STATUS OF CLAIMS

REMARKS

Objection to Drawings

Fig. 5

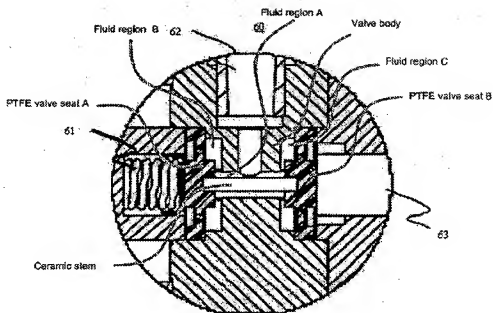
The prior art Takasago three-way valve, as can be seen from FIG 5 (prior art), provided below with annotations, is a pneumatically activated valve (via pneumatically activated plunger 63) with a spring return 61.

The valve contains an assembly that includes two PTFE valve diaphragm seals mechanically interlocked with a small ceramic stem (“the Takasago assembly”). As can be seen from FIG 5, the PTFE valve diaphragm seals are *fixed* such that they cannot move horizontally without deformation. Moreover, the PTFE diaphragm seals are elastic and in the absence of any horizontal force (i.e., pneumatic force or spring force), would be centered with respect to the valve body (which is shown in right-hand downward cross-hatching) such that a gap is created between the valve diaphragm seals and the valve seats such that both valve seats are *open*. However, when the plunger 63 of FIG 5 is pneumatically activated, it drives the assembly to the left. This overcomes the force being exerted by the spring return 61 and allows the PTFE valve seat A to pull away from the valve body, resulting in fluid communication between fluid region A (which is connected to a first common port) and fluid region B (which is connected to a second port). This also pushes the PTFE valve diaphragm seal B against the valve seat of the valve body, precluding fluid communication between fluid region A and fluid region C (which is connected to a third port). On the other hand, when the pneumatic pressure is *removed*, the assembly is driven to the *right* by the spring return 61, forcing the PTFE valve diaphragm seal A against the valve seat of the valve body, and preventing fluid communication between fluid region A and fluid region B. The PTFE valve diaphragm seal B, on the other hand, is pulled

away from the valve body, allowing fluid communication between fluid region A and fluid region C. Thus, due to the presence of the spring return in the valve of FIG 5, there is ***always an actuating force***, even when the supply pressure operating the valve is removed (e.g., when the valve is not in use). Consequently, there is never a situation in which the assembly is not being urged to left or right, and thus the assembly is never allowed to become centered with respect to the valve body (due to the elastic rebound of the PTFE material). As such, there is never a situation where both valve diaphragm seals are open causing a gap opening between the seals and the valve seats (i.e., at its “equilibrium” position). Moreover, when the supply pressure operating the valve is removed from the valve of FIG 5, the PTFE valve A is forced against the valve body by the spring return, and many times results in the valve becoming glued shut in this position.

All of the above is in contrast to the present invention which is mechanically configured such that “all valve seats of the medical device [are] ***open*** when the unit is not in use.” (paragraph [0005]) (emphasis added). Referring to Figs. 9, 11 and 18, which shows an embodiment of the present invention, the three-way valve of the present invention has two ends, which remain open when the unit is not in use, i.e., unit is in a default neutral state. Both valve seats are pneumatically driven and there is no spring return. Thus, when the pneumatic force is removed from the valve (e.g., when the valve is not in use), the assembly is neither forced to the left nor to the right, allowing the assembly to return to its centered “equilibrium” position when both valve seats are open. This completely opens the valve (i.e., establishing fluid communication between fluid region A and fluid region B at the same time as establishing fluid communication between fluid region A and fluid region C). More importantly, when the spray coat machine of the present invention is not in use, ***neither valve seat is held closed, which eliminates the possibility of the valve becoming glued shut.*** See paragraph [0033].
